Merged Document Report

Application No.: PL9043

Description :	
Address :	
Record Type :	PLAT

FINAL PLAT OF NEMEC TOWNE CENTER PHASE 2, BLOCK 1

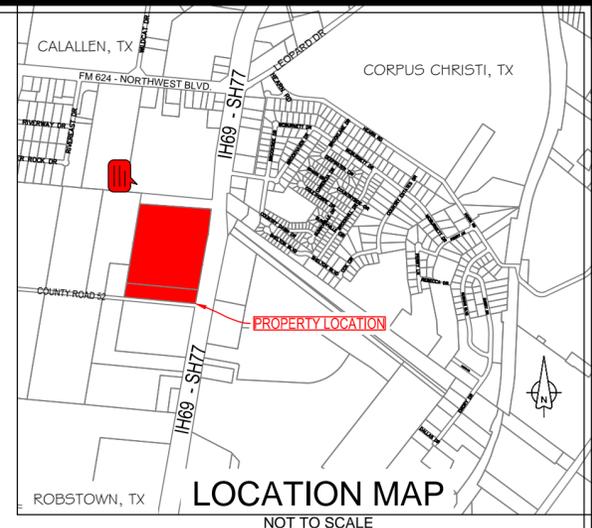
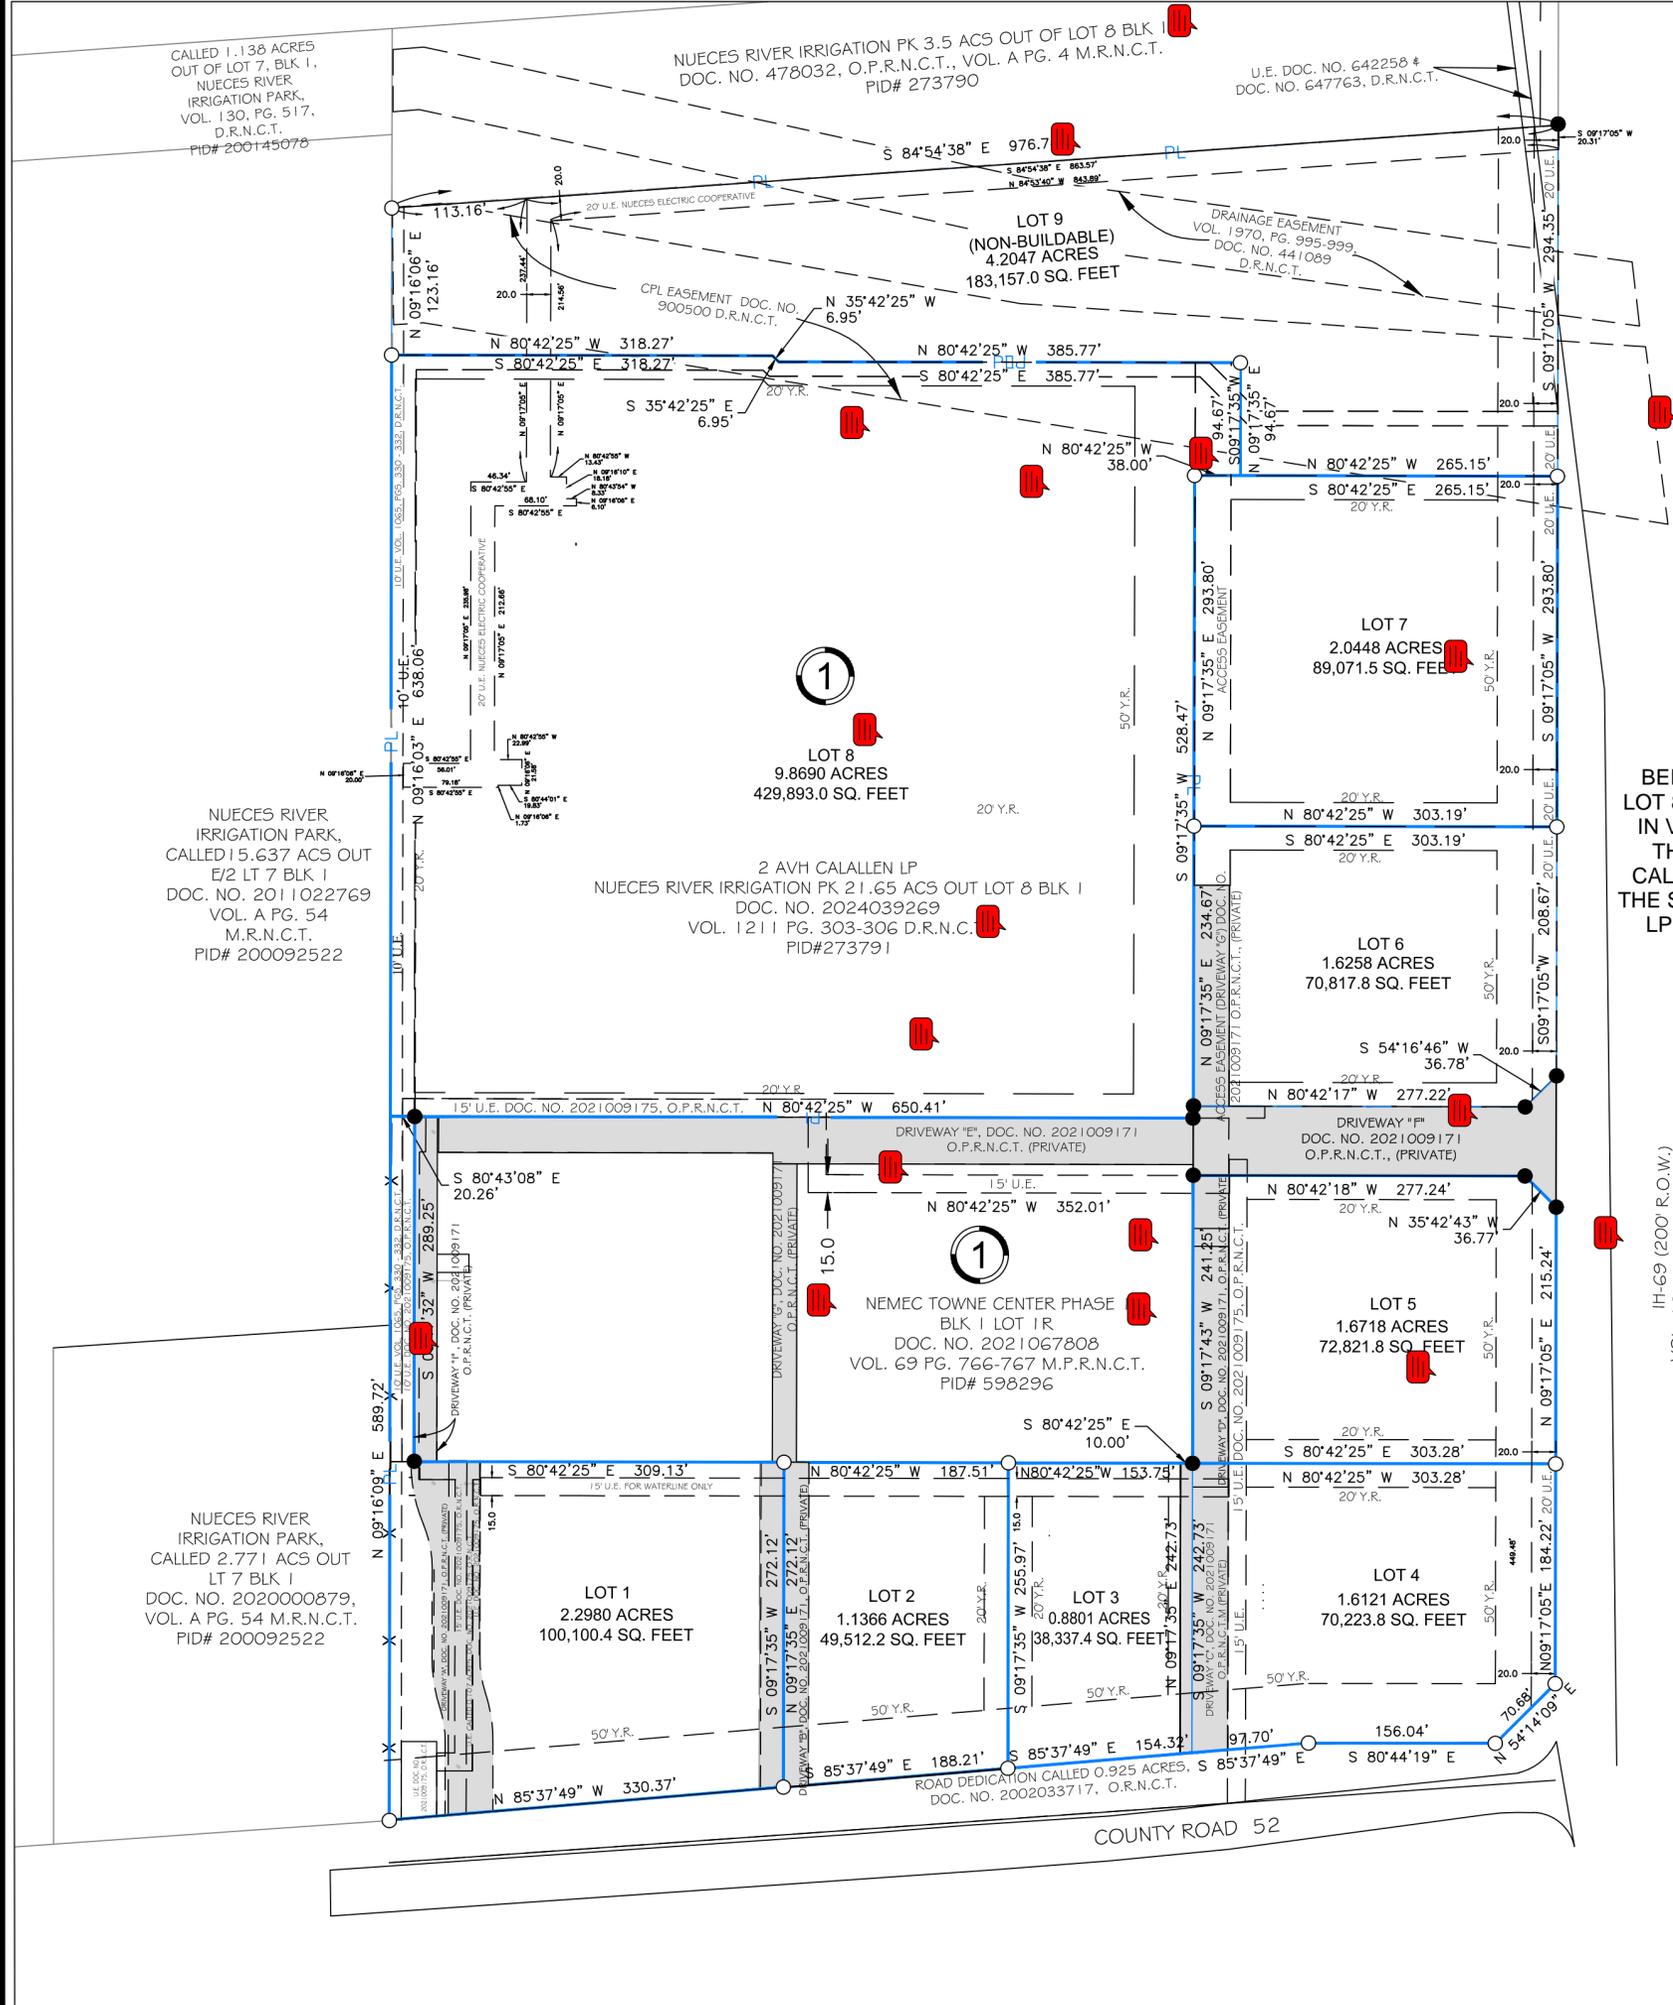
30	P002	Note	Mina Trinidad : DS	Closed	Remove the "Preliminary, this document shall not be recorded" verbiage from the plat.	
7	Utility Plan	Note	Mina Trinidad : DS	Closed	<p>Fire: (Captain Mark Lewis)</p> <p>12/9/25 Update: Mina, all Fire concerns have been addressed and Fire approves of PL9043 TRC 2 Nemec Towne Center Phase 2 (3601 IH 69).</p>

Comment ID	Page Reference	Annotation Type	Author : Department	Status	Review Comments	Applicant Response Comments
					<p>Comments 1-3</p> <p>1. Note: All code reference is based on currently adopted International Fire Code (IFC) 2021 and Corpus Christi Water Distribution Standards.</p> <p>2. Commercial Development shall have a fire flow of 1,500 GPM with 20 psi residual Fire hydrant every 300 feet and operational.</p> <p>3. Water supply in this area of the city may not support this required fire flow. A water supply study should take place to ensure adequate fire protection is in place.</p>	
8	Utility Plan	Note	Mina Trinidad : DS	Closed	<p>(Informational) Fire: Comments 4-10</p> <p>4. 507.5.4 Obstruction. Unobstructed access to fire hydrants shall be maintained at all times. The fire department shall not be deterred or hindered from gaining immediate access to fire protection equipment or fire hydrants. Note: Hose lay from a hydrant will not cross an arterial street.</p> <p>5. 912.2.3 (amendment) Proximity to Hydrant: Fire department connections (FDC) for each sprinkler system or standpipe system shall be located not more than 100 feet from the nearest fire hydrant connected to an approved water source</p> <p>6. 503.1.1 (amendment) Buildings and facilities: Approved fire apparatus access roads shall be provided for every facility, building, or portion of a building hereafter constructed or moved into or within the jurisdiction. The fire apparatus access road shall allow access to three (3) sides of buildings in excess of fifteen thousand (15,000) square feet and all sides for buildings in excess of thirty thousand (30,000) square feet.</p> <p>7. 3310.1 Required access. Approved vehicle access for firefighting shall be provided to all construction or demolition sites. Vehicle access shall be provided to within 100 feet of temporary or permanent fire department connections. Vehicle access shall be provided by either temporary or permanent roads, capable of supporting vehicle loading under all weather conditions. Vehicle access shall be maintained until permanent fire apparatus access roads are available.</p> <p>8. D102.1 Access and loading. Facilities, buildings, or portions of buildings hereafter constructed shall be accessible to fire department apparatus by way of an approved fire apparatus access road with an asphalt, concrete or other approved driving surface capable of supporting the imposed load of fire apparatus weighing at least 75,000 pounds.</p>

Comment ID	Page Reference	Annotation Type	Author : Department	Status	Review Comments	Applicant Response Comments
					<p>9. 503.1.1 (amendment) Buildings and facilities: During construction, when combustibles are brought on to the site in such quantities as deemed hazardous by the fire official, access roads and a suitable temporary supply of water acceptable the fire department shall be provided and maintained.</p> <p>10. Note: An accessible road and a suitable water supply is required once construction materials are brought on site.</p>	
9	Utility Plan	Note	Mina Trinidad : DS	Closed	<p>(Informational) Fire: Comments 11-15</p> <p>11. 503.2.1 Dimensions. Fire apparatus access roads shall have an unobstructed width of not less than 20 feet, exclusive of shoulders and an unobstructed vertical clearance of not less than 13 feet 6 inches.</p> <p>12. D103.1 Access road width with a hydrant. Where a fire hydrant is located on a fire apparatus access road, the minimum road width shall be 26 feet, exclusive of shoulders.</p> <p>13. The minimum required width of 20 feet that shall be maintained means a clear unobstructed path that allows the passage of fire apparatus. Where Fire Apparatus Access is constructed to the minimum of 20 feet, no parking is allowed within the fire apparatus lane. Where a fire hydrant is located on the street, the minimum unobstructed clearance shall be 26 feet. In this instance, no parking is allowed on one side of the street. The minimum UDC residential street width is 28 ft. curb to curb. Any parking along the street that reduces the width to less than 20 ft. is prohibited and the Fire Code Official and will require painting "NO PARKING-FIRE LANE" along one side of the street.</p> <p>14. Note: Calculated Turning Radii for Fire Apparatus: Inside Turn: 20 ft. 3 in. Curb to curb: 36 ft. 8 in. Wall to wall: 44 ft. 8 in. Note: The turning radius for fire apparatus should not be less than 45 degrees and curb to curb 36 feet. As a result, developers should be particularly careful not to design streets with acute angles that would prevent fire apparatus from completing a turn without having to back up to negotiate the turn.</p> <p>15. D105.1 Where required. Where the vertical</p>

Comment ID	Page Reference	Annotation Type	Author : Department	Status	Review Comments	Applicant Response Comments
					distance between the grade plane and the highest roof surface exceeds 30 feet, approved aerial fire apparatus access roads shall be provided. For purposes of this section, the highest roof surface shall be determined by measurement to the eave of a pitched roof, the intersection of the roof to the exterior wall, or the top of parapet walls, whichever is greater	
10	Utility Plan	Note	Mina Trinidad : DS	Closed	<p>(Informational) Fire Comments 16-24</p> <p>16. D105.2 Width. Aerial fire apparatus access roads shall have a minimum unobstructed width of 26 feet, exclusive of shoulders, in the immediate vicinity of the building or portion thereof.</p> <p>17. D105.3 Proximity to building. At least one of the required access routes meeting this condition shall be located within a minimum of 15 feet and a maximum of 30 feet from the building and shall be positioned parallel to one entire side of the building. The side of the building on which the aerial fire apparatus access road is positioned shall be approved by the fire code official.</p> <p>18. D105.4 Obstructions. Overhead utility and power lines shall not be located over the aerial fire apparatus access road or between the aerial fire apparatus road and the building. Other obstructions shall be permitted to be placed with the approval of the fire code official.</p> <p>19. 503.4 Obstruction of fire apparatus access roads. Fire apparatus access roads shall not be obstructed in any manner, including the parking of vehicles. The minimum widths and clearances established in sections D103 shall always be maintained.</p> <p>20. 503.3 Marking: Where required by the fire code official, approved signs, or other approved notices the include the words NO PARKING-FIRE LANE shall be provided for fire apparatus access roads to identify such roads to prohibit the obstruction thereof. The designation of a fire lane can be marked with conspicuous signs which have the words: " Fire Lane-No Parking" at 50-foot intervals. In lieu of signs, fire lanes may be marked along curbing with the wording, "Fire Lane-No Parking" at 15-foot intervals.</p> <p>21. Table D103.4 Requirements for Dead-end fire apparatus access roads. Turnaround provisions shall be provided with a 96-foot diameter cul-de-sac.</p>

Comment ID	Page Reference	Annotation Type	Author : Department	Status	Review Comments	Applicant Response Comments
					<p>22. 503.2.5 Dead ends. Dead-end fire apparatus access roads more than 150 feet in length shall be provided with an approved area for turning around fire apparatus.</p> <p>23. D103.5 Fire apparatus access road gates. If installed-Gates securing the fire apparatus access roads shall comply with all the following criteria: Single gate width shall not be less than 20 feet. 12 feet gate width is required for a divided roadway. Electric gates shall be equipped with a means of opening the gate by fire department personnel for emergency access. Emergency opening devices shall be approved by the fire code official. Note: The use of a Knox Gate Switch is currently required by the Fire Official. Methods of locking shall be submitted for approval by the fire code official. Note: The Knox Padlock is currently required by the Fire Official. Electric gate operators, where provided, shall be listed in accordance with UL 325. Gates intended for automatic operation shall be designed, constructed, and installed to comply with the requirements of ASTM F 2200.</p> <p>24. Commercial development of the property will require further Development Services review.</p>

13	Utility Plan	Note	Mina Trinidad : DS	Closed	<p>CCW: (Edgar Diaz Ruiz)</p> <p>12/15/25 Update: Additional comment: 1. Please provide estimated water/wastewater flows in public improvements.</p> <p>Water service will need to be coordinated with Nueces County WCID 3, CCW does not provide water to this area. Wastewater construction is required for platting (UDC 1.2.1.D & 8.2.7; Wastewater Collection System Standards). All wastewater improvements to be address during Public Improvements Phase.</p>	
1	Application	Note	Mina Trinidad : DS	Closed	<p>The following items are required to be submitted: 1. Storm Water Quality Management Plan (SWQMP) 2. Utility Plan 3. Peak Hour Trip (PHT) Form 4. Deed for the property</p>	
2	Application	Note	Mina Trinidad : DS	Closed	Ensure zoning is correct on application.,	
3	Application	Note	Mina Trinidad : DS	Closed	Please fill out all information on application (Tax ID and Plat Review tract)

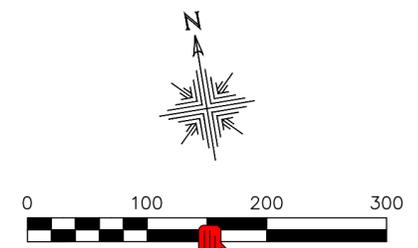
Comment ID	Page Reference	Annotation Type	Author : Department	Status	Review Comments	Applicant Response Comments
					<p>TxDOT's discretion and approval, prior to the access connection being establish.</p> <p>Nemec Towne Center has been approved for a driveway for both phase 1 and 2 to access US 77/ I 69 Southbound Frontage Road. CR 52 is not on our state's trunkline system.</p>	
17	P002	Note	Mina Trinidad : DS	Closed	(Informational) CCIA: This Plat does not fall within the Corpus Christi International Airports MCA overlay. There I have no comments.	
18	P002	Note	Mina Trinidad : DS	Closed	Remove Michael York name and add: Cynthia Salazar-Garza Chairperson	
19	P002	Note	Mina Trinidad : DS	Closed	Change Michael Dice signature to "Director."	
20	P002	Note	Mina Trinidad : DS	Closed	Remove "Preliminary Plat" and change to "Final Plat"	
21	P002	Note	Mina Trinidad : DS	Closed	Change text under heading to "Being a final plat of..."

22	P002	Note	Mina Trinidad : DS	Closed	Include the yard requirement/zoning general note on the plat.	
23	P002	Note	Mina Trinidad : DS	Closed	Include the CG-2 General Commercial District yard requirements on the plat.	
24	P002	Note	Mina Trinidad : DS	Closed	Remove any existing structures shown on the plat.	
25	P002	Note	Mina Trinidad : DS	Closed	Will the existing street names remain? Ex: "Driveway E?" If streets are private, please label streets as private.	
26	P002	Note	Mina Trinidad : DS	Closed	Ensure all markings within plat are legible.	
27	P002	Note	Mina Trinidad : DS	Closed	(Informational) Streets: Public Works Streets does not have any comments.	
28	P002	Note	Mina Trinidad : DS	Closed	Revised scale of location map, focus more on the subject property and ensure all streets are legible surrounding the property.	
29	P002	Note	Mina Trinidad : DS	Closed	Write "non-buildable" under Lot 9 within the plat.
